## Final Environmental Impact Statement Continental Divide/Wamsutter II Natural Gas Project, Sweetwater and Carbon Counties, Wyoming

FINAL  
ENVIRONMENTAL IMPACT STATEMENT  
CONTINENTAL DIVIDE/WAMSUTTER II  
NATURAL GAS PROJECT,  
SWEETWATER AND CARBON COUNTIES,  
WYOMING

MODIFICATIONS, CORRECTIONS, AND ADDITIONS TO  
THE CONTINENTAL DIVIDE/WAMSUTTER II  
DRAFT ENVIRONMENTAL IMPACT STATEMENT

Map 2.3 Sensi, Wyoming, 1999.

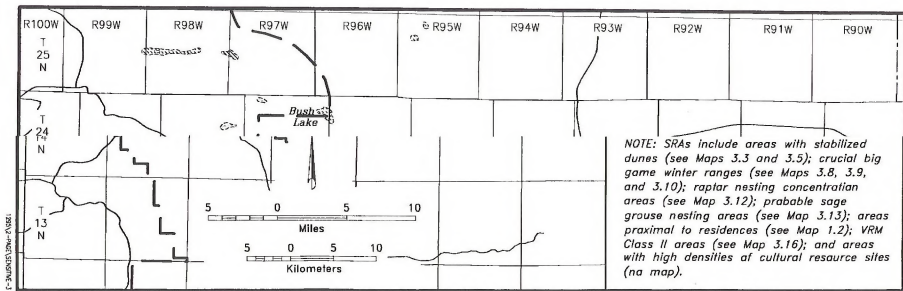
Page 2-7, Map 2.3. Delete Map 2.3 and replace with revised Map 2.3.

Map B-1.1 General Location Map for the Continental Divide/Wamsutter II Project, Sweetwater and Carbon Counties, 1999.

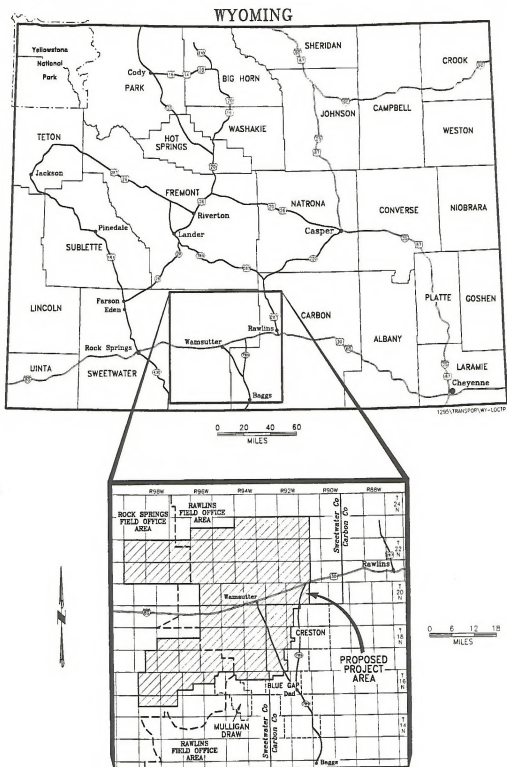
Page B-2, Map B-1.1. Delete Map B-1.1 and replace with the following revised map.

**Comment Response 1** - The map has been corrected (see FEIS Appendix B, Map B-1.1). Thank you for bringing this to our attention.

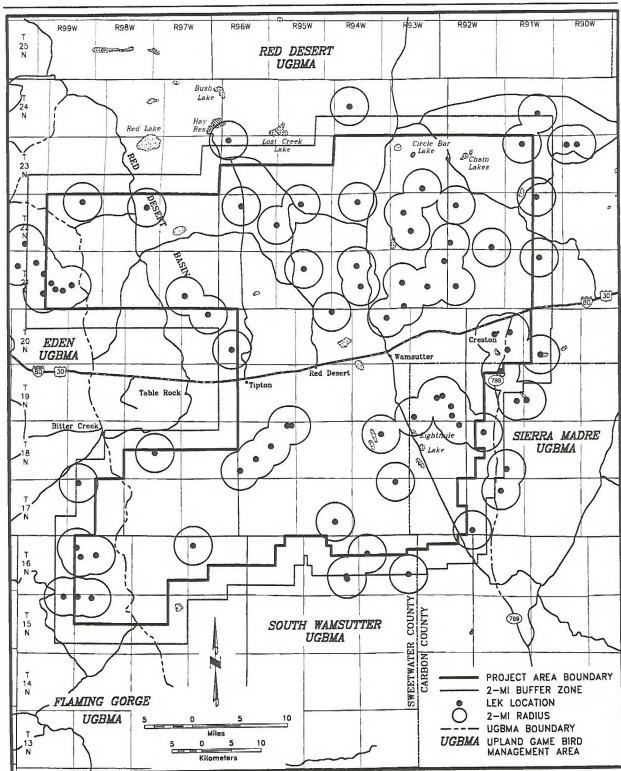
Page D-18, Map D-2.3. Delete Map D-2.3 and replace with the following revised map.
